1001 JOHN ST

SEATTLE WA, 98109
DPD# 3020563

COMFORT LETTER
JUNE 14, 2017

Previous Tower Separation Plan

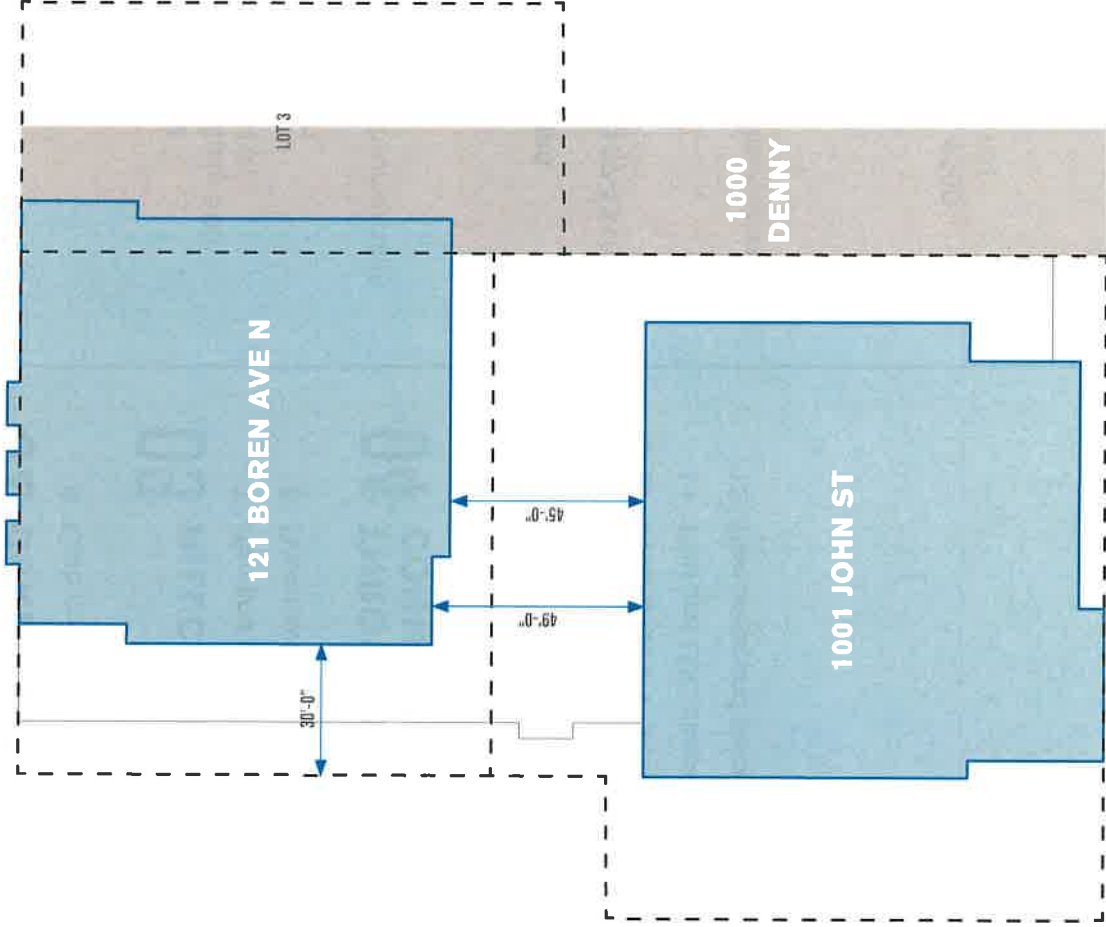
Given we are now a single project with 2 towers instead of two separate projects, are there any unforeseen issues with the proposed separation departure increasing from 42' to 45'?

Current Curb Cuts

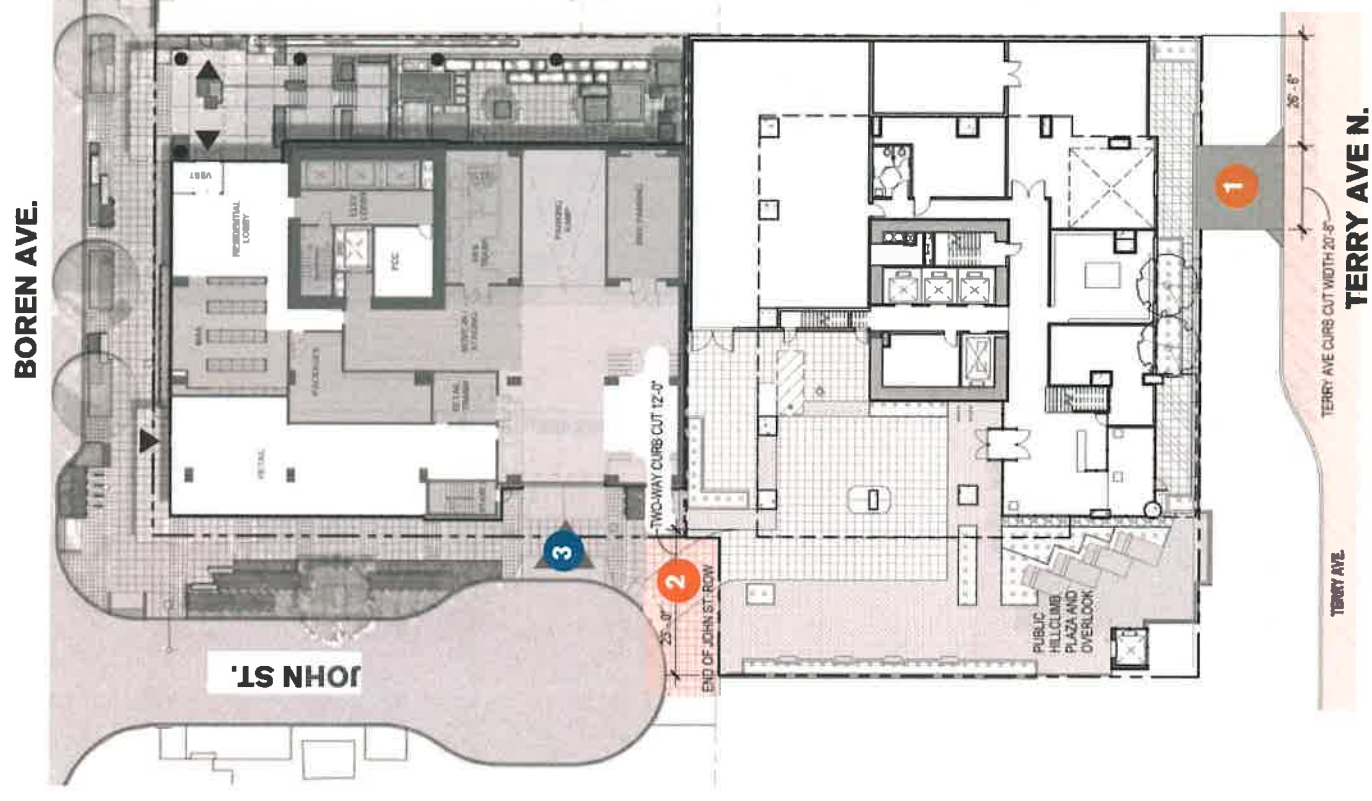
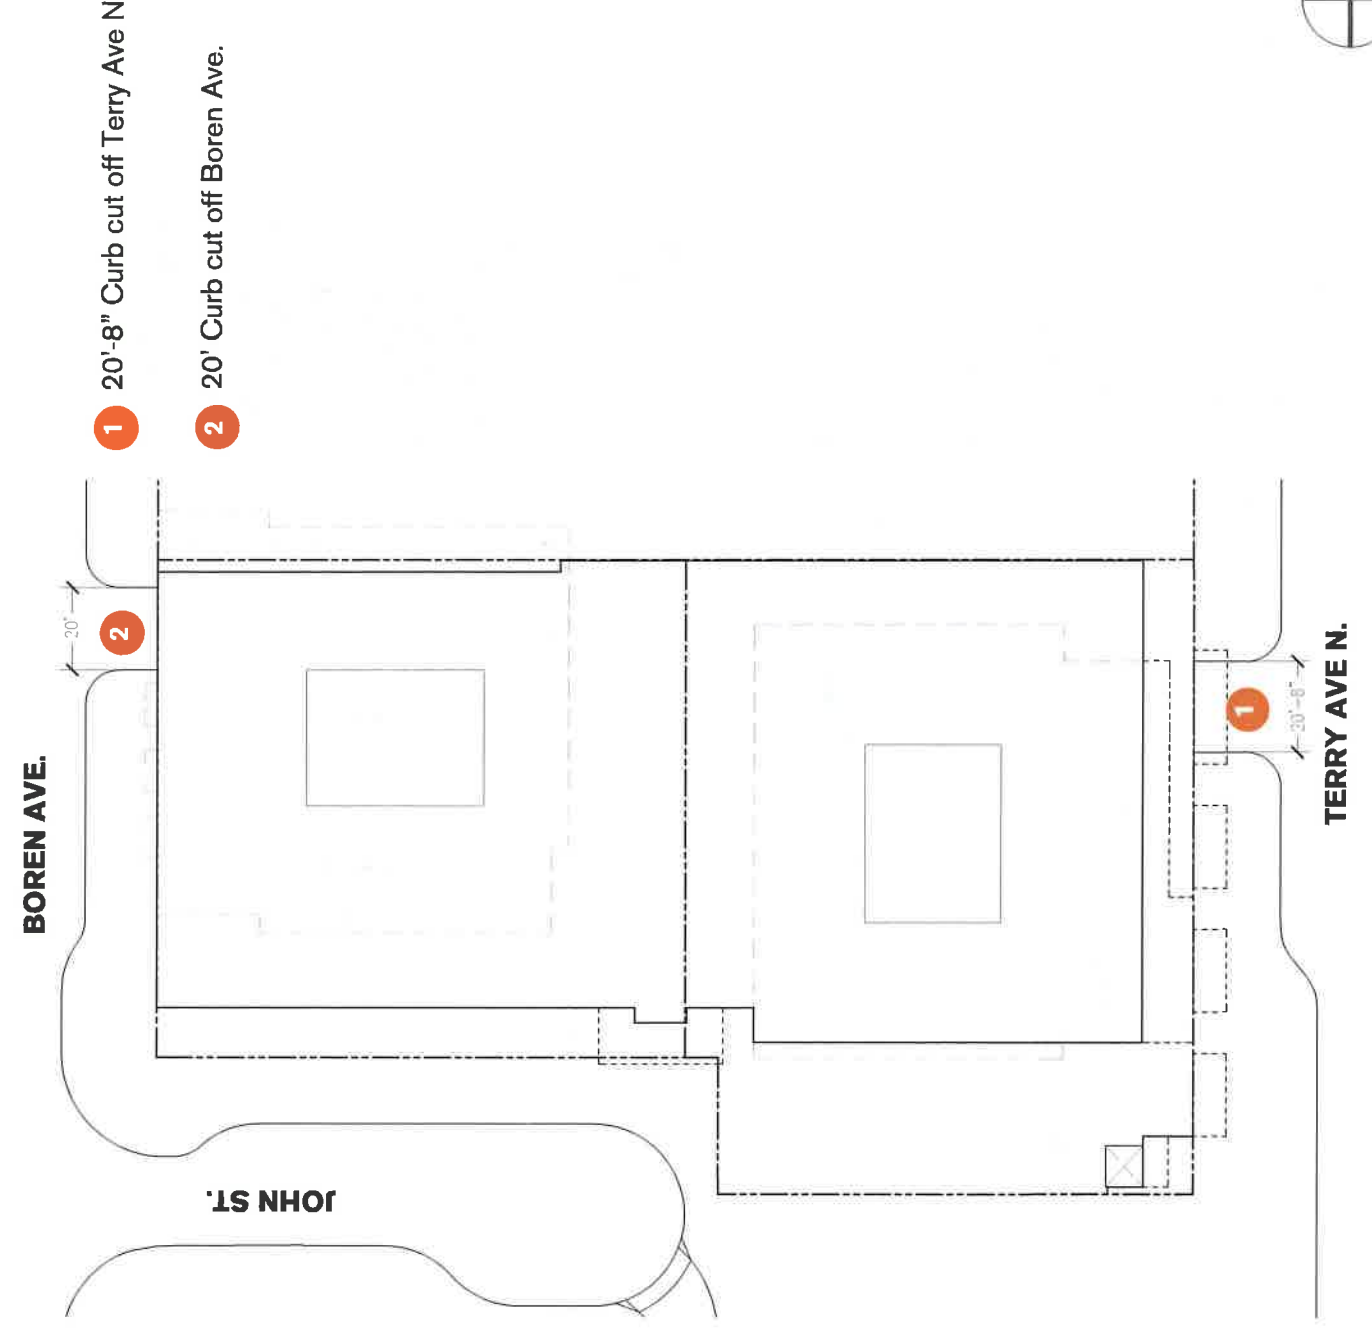
Beyond the design review departure, are there any additional issues with having 2 curb cuts? One off Terry Ave N. and one off Boren Ave.

SLU LAND USE CODE (HILLCLIMB)

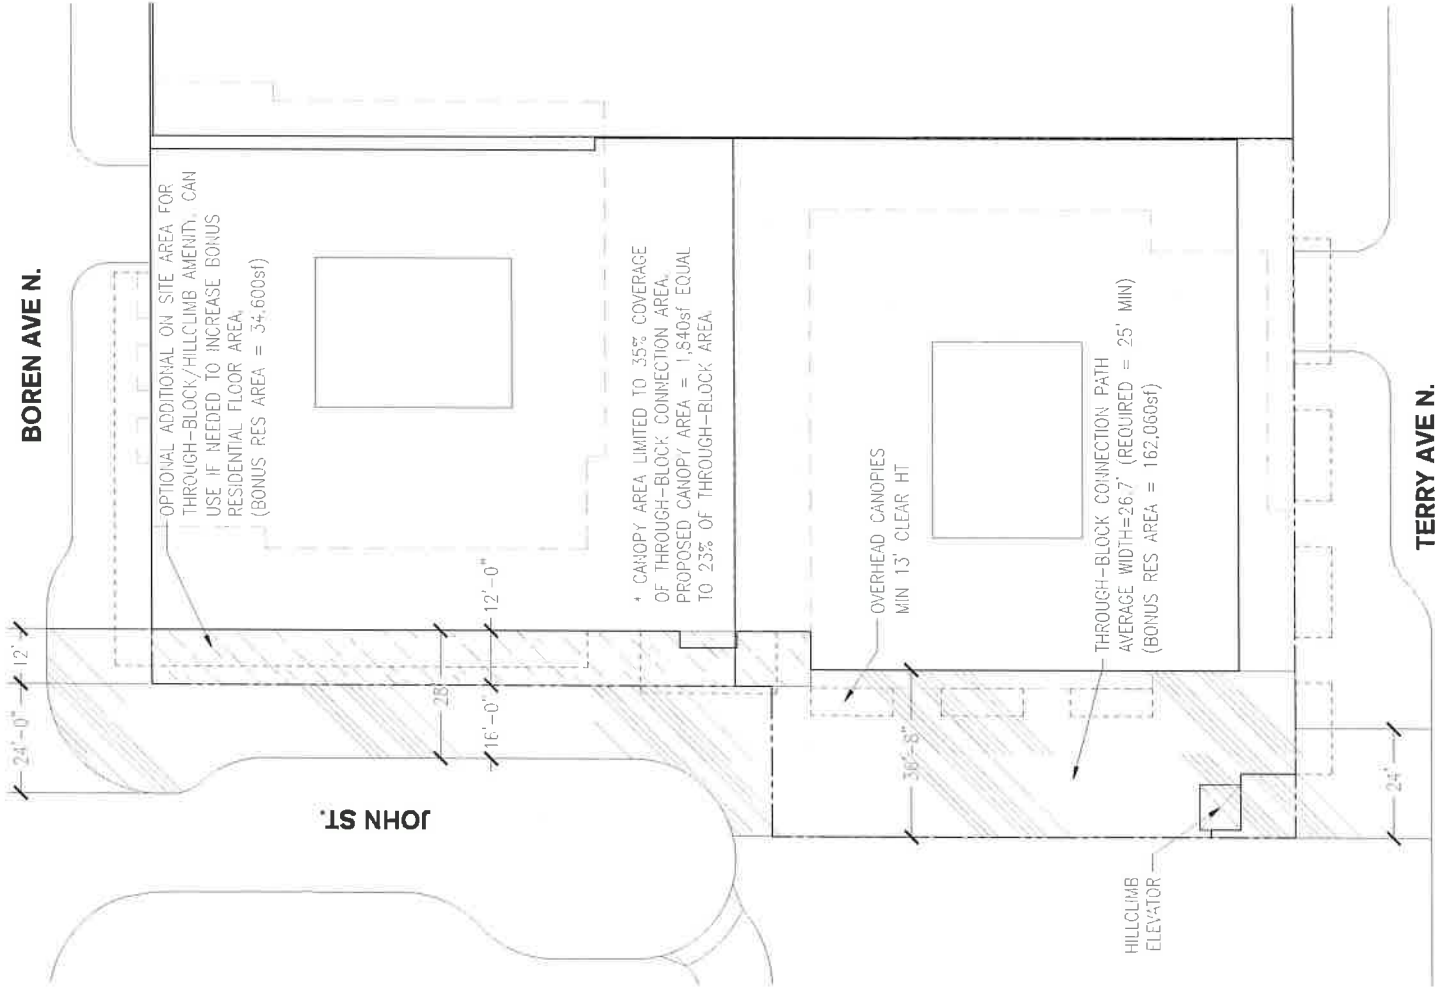
Are there any issues with the proposed hillclimb location?

SLU LAND USE CODE (THROUGH-BLOCK)

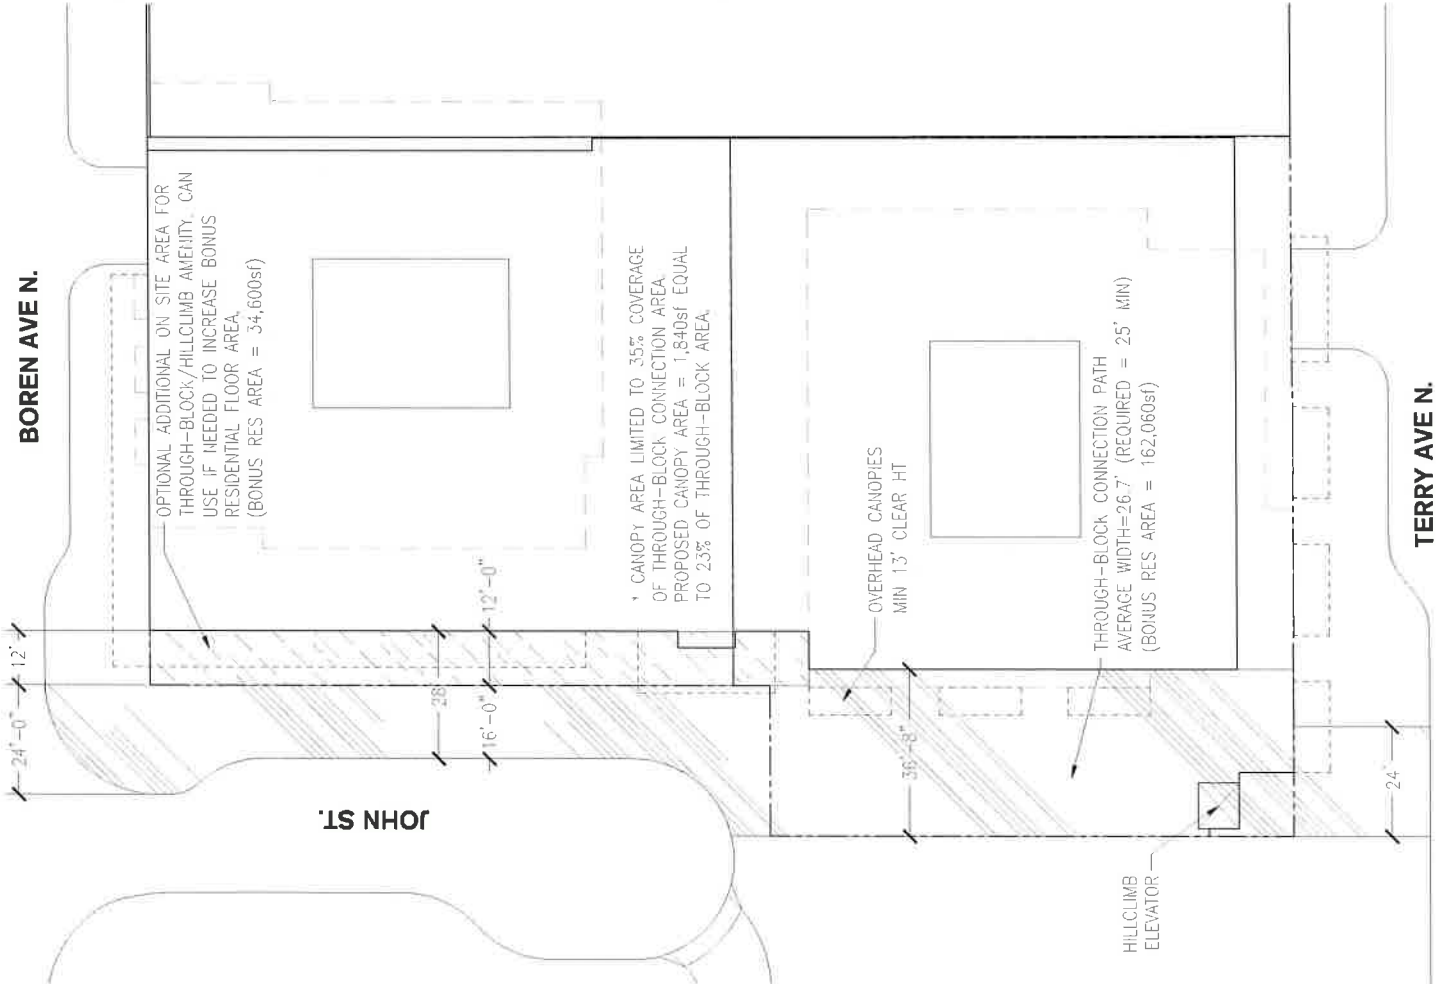
Is the proposed location of the through-block connection acceptable? Do we need a departure or a type 1 decision based the proposed location?

3. The Director may allow modifications or waiver from the standards for though-block pedestrian connections as a Type I decision, if the applicant demonstrates that alternative treatments will better serve the development by enhancing pedestrian comfort and promoting greater use of the connection. (Do we need a Type I decision or a departure for it's location?)

AMENITY AREA PLAN DIAGRAMS

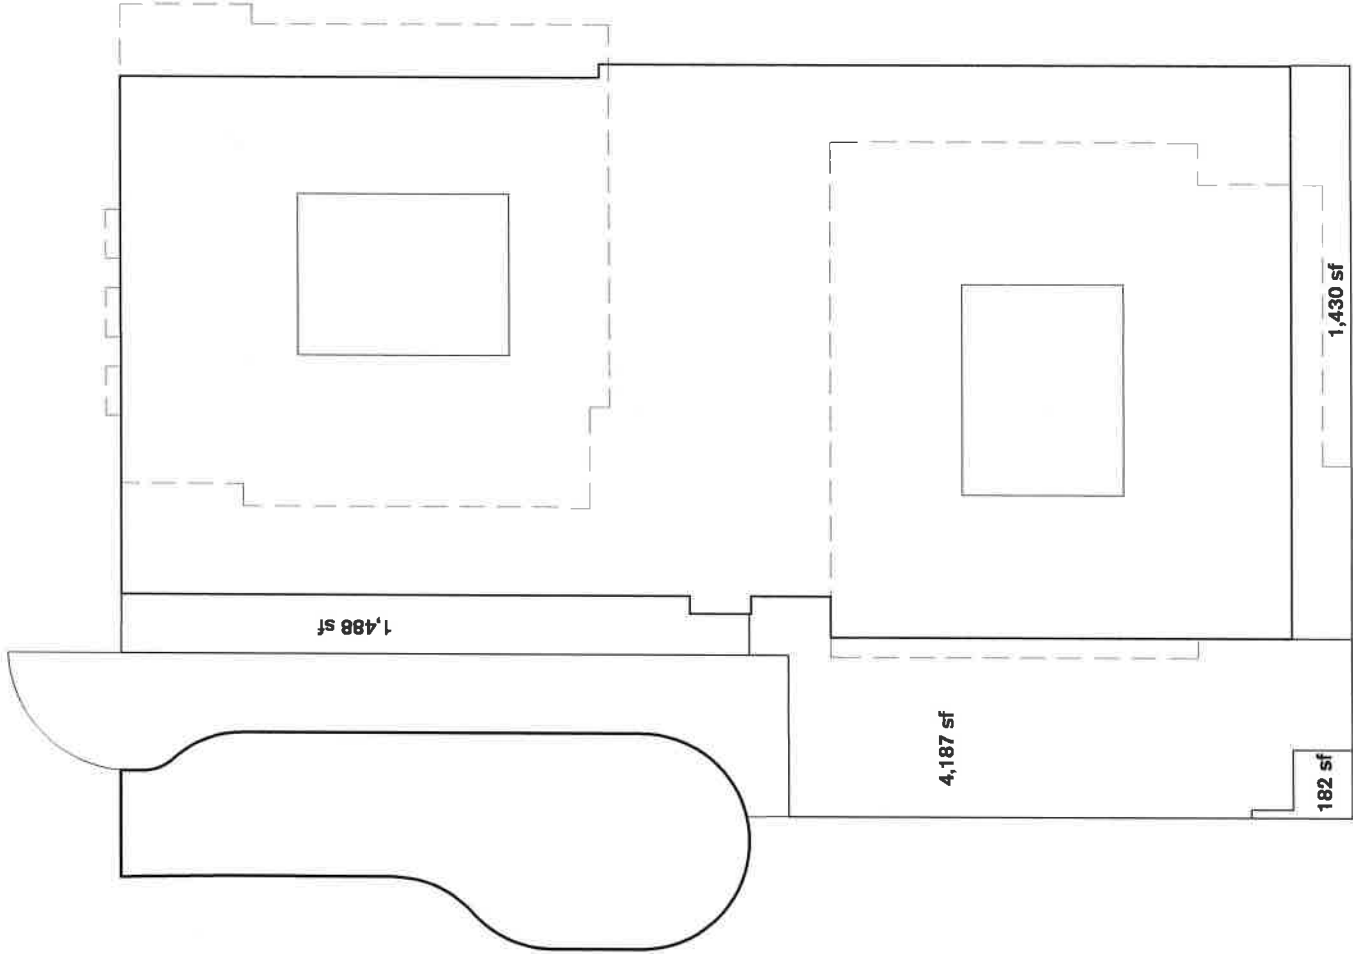
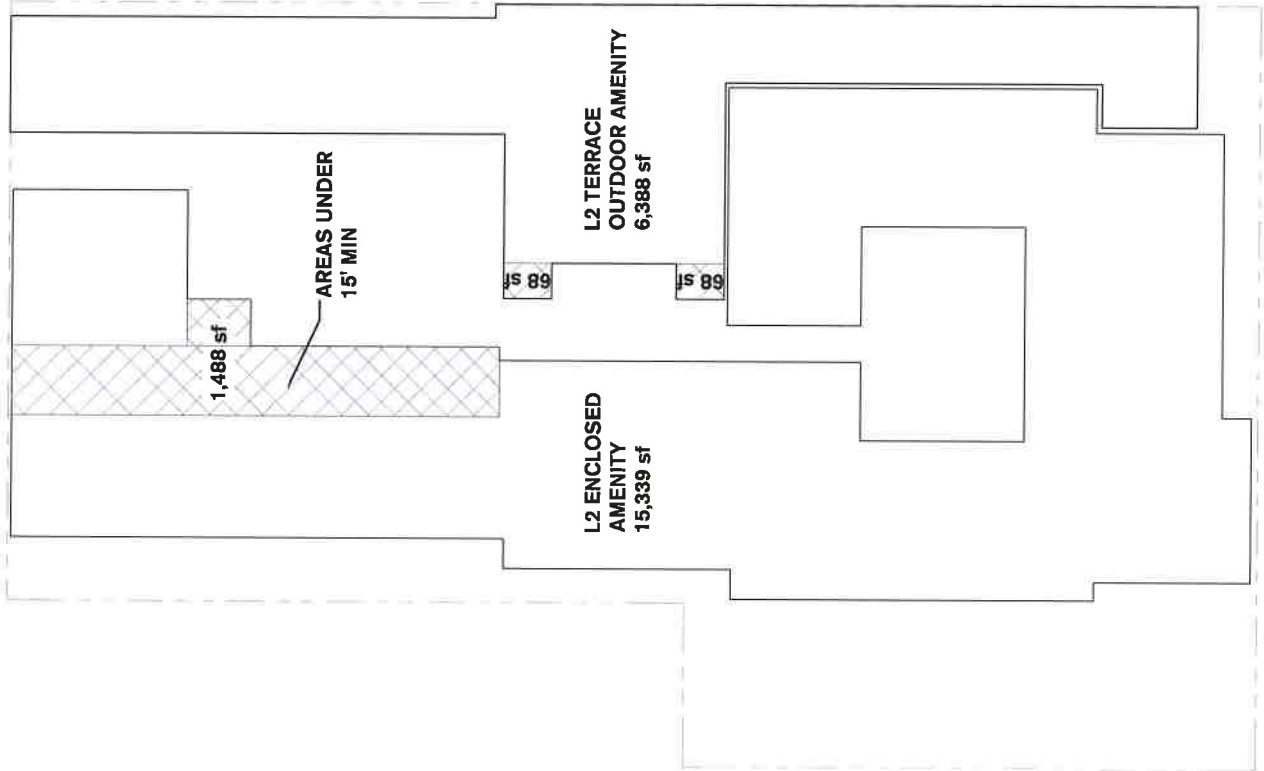
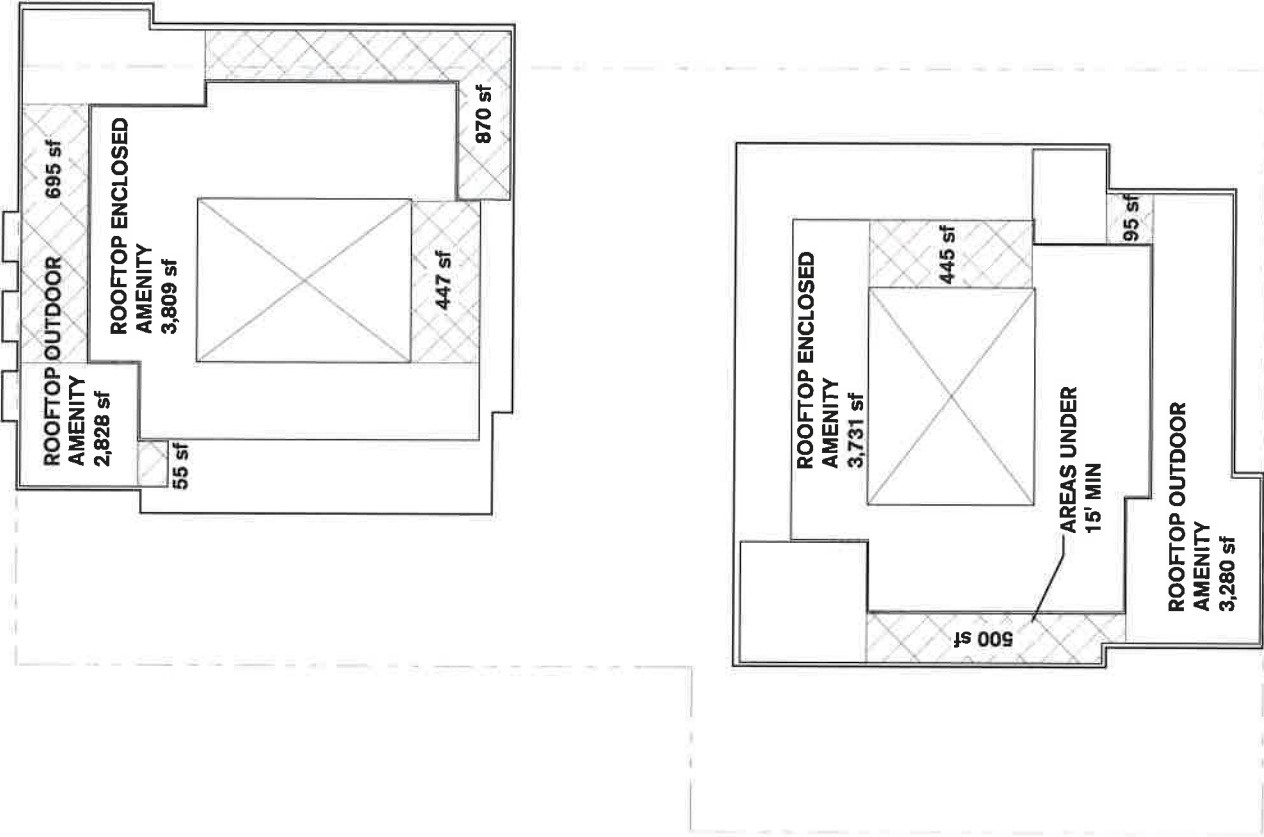
Is there any issue with the proposed amenity area?

6. Parking areas, driveways, and pedestrian access, except for pedestrian access meeting the Washington State Rules and Regulations for Barrier Free Design, shall not be counted as amenity area except that a woonerf may provide a maximum of 50 percent of the amenity area if the design of the woonerf is approved through a design review process pursuant to Chapter 23.41. (Currently the proposed project does not need to count woonerf area. Are there any issues/advantages if we count a woonerf?)	?

8. For lots abutting a designated Neighborhood Green Street, up to 50 percent of the amenity area requirement may be met by contributing to the development of the abutting Neighborhood Green Street. The Director may waive the requirement that the Neighborhood Green Street abut the lot and allow the improvement to be made to a Neighborhood Green Street located in the general vicinity of the project if the Director determines that the Neighborhood Green Street will benefit residents of the project. (Currently the proposed project does not need to count improved green street area. Are there any issues/advantages if we count green street improvements?)	?
